## Duquesne Light

2NRC-4-207

SUBJECT: Beaver Valley Power Station - Unit No. 2  
Docket No. 50-412  
Responses to NRC Structural Engineering Section's Draft SER  
Open and Confirmatory Items

### Structural & Geotechnical Engineering Branch Remaining Open and Confirmatory Items from Structural Engineering Section

FIGURE 2-16  
INTAKE STRUCTURE SOIL PROFILE  
BEAVER VALLEY POWER STATION-UNIT 1

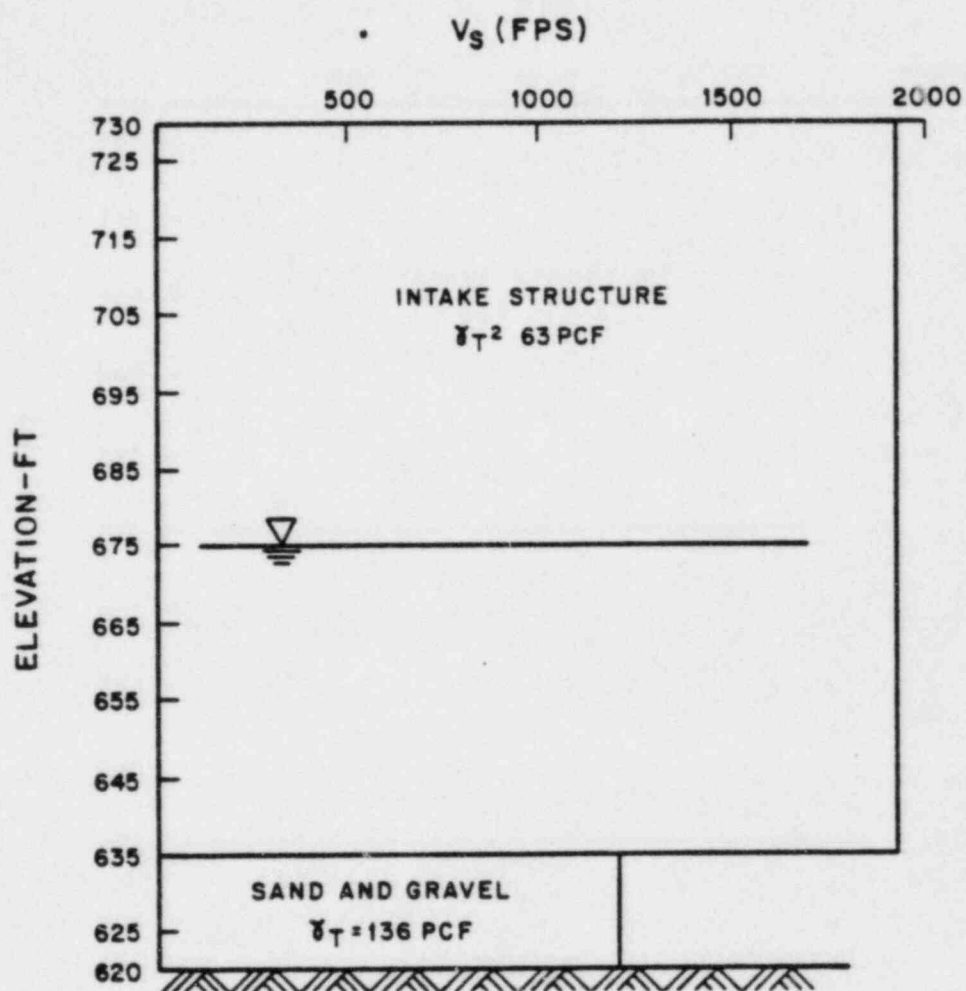
Refer to Figure 2-16 and

Change  $\gamma_T$  2 63 pcf
